**H. B. ROBINSON STEAM ELECTRIC PLANT (HBRSEP), UNIT NO. 2
DOCKET NO. 50-261 / RENEWED LICENSE NO. DPR-23**

**2016 ANNUAL RADIOACTIVE EFFLUENT RELEASE REPORT AND
OFFSITE DOSE CALCULATION MANUAL, CURRENT REVISION 34**

RADIOACTIVE EFFLUENT RELEASE REPORT

JANUARY 1, 2016 – DECEMBER 31, 2016

FIGURE 4-1
RADIOLOGICAL SAMPLE LOCATIONS NEAR SITE

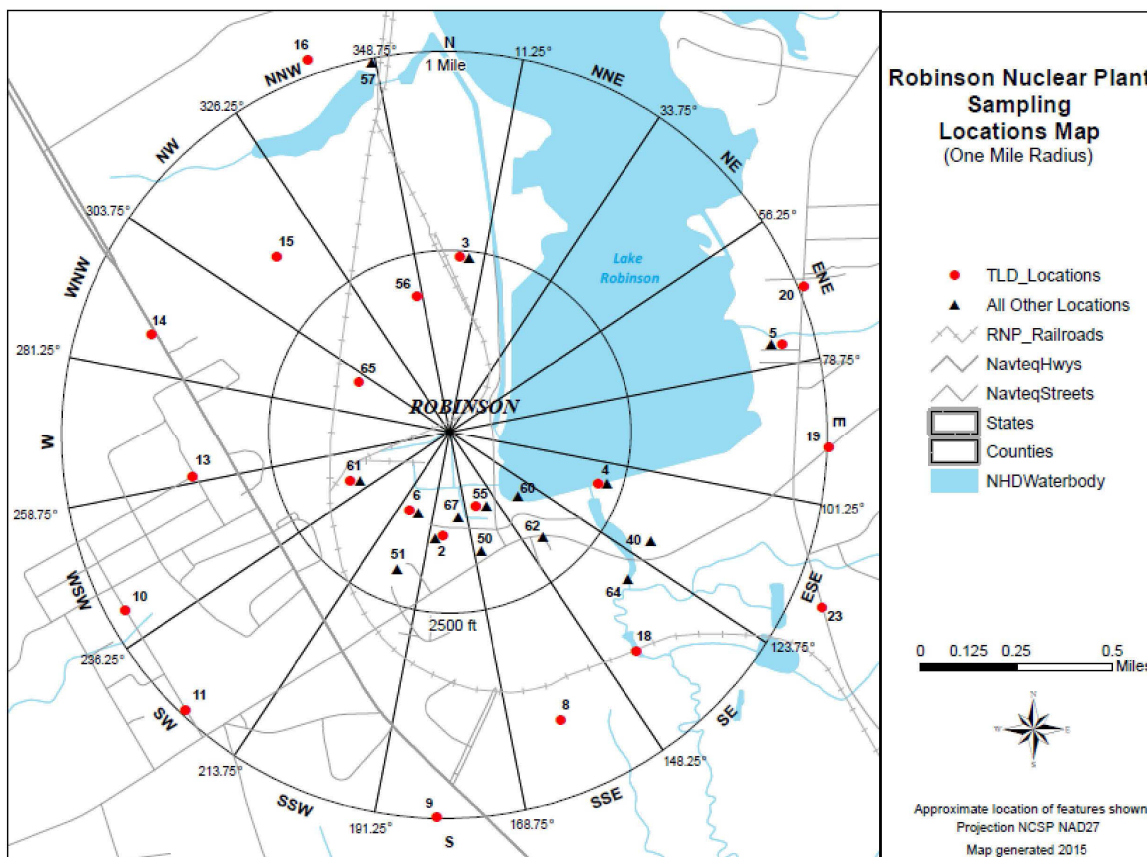
Figure 4-1 - Page 4-24

Updated Figure 4-1 to reflect removal of Groundwater locations 42 and 68 - 82 from ODCM.

Change made to reflect updated Figure 4-1 and Figure 4.2 displaying locations within specified range.

FIGURE 4-2
RADIOLOGICAL SAMPLE LOCATIONS DISTANT LOCATIONS

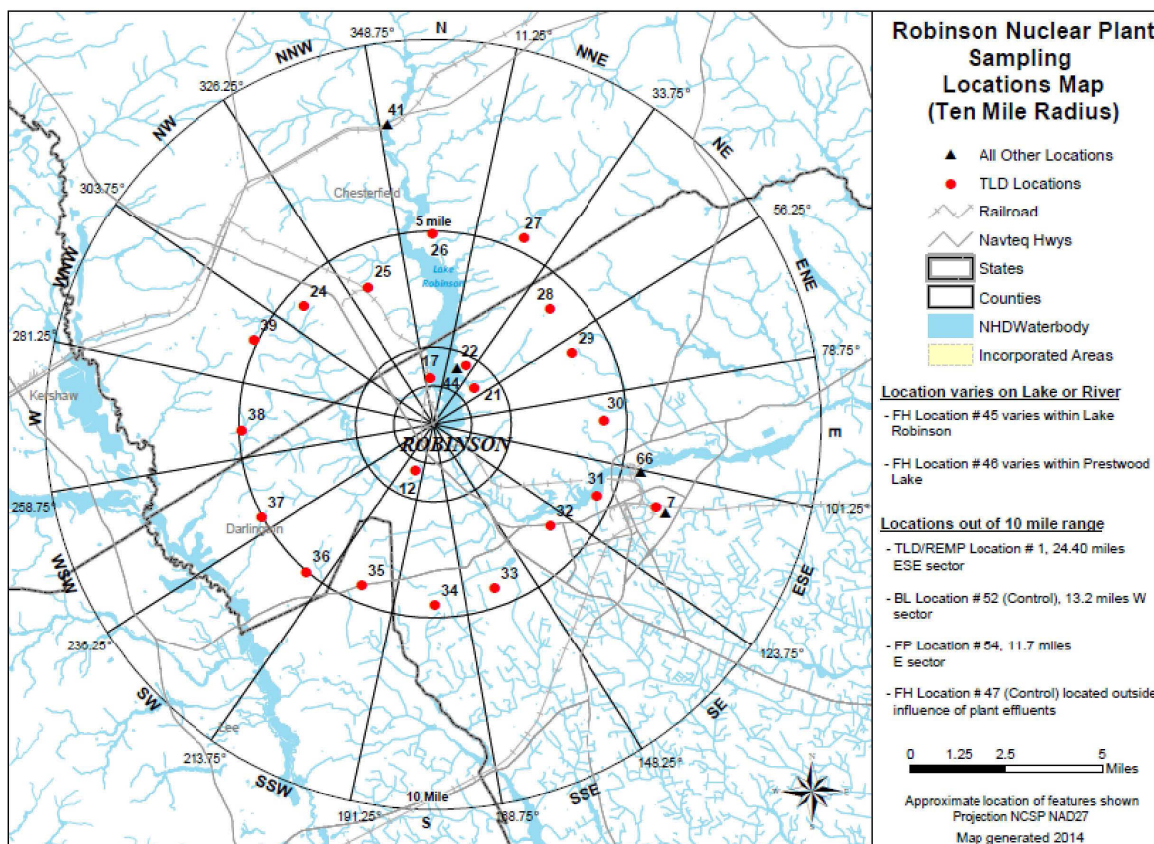
Figure 4-2 - Page 4-25

Change made to reflect updated Figure 4-1 and Figure 4.2 displaying locations within specified range.
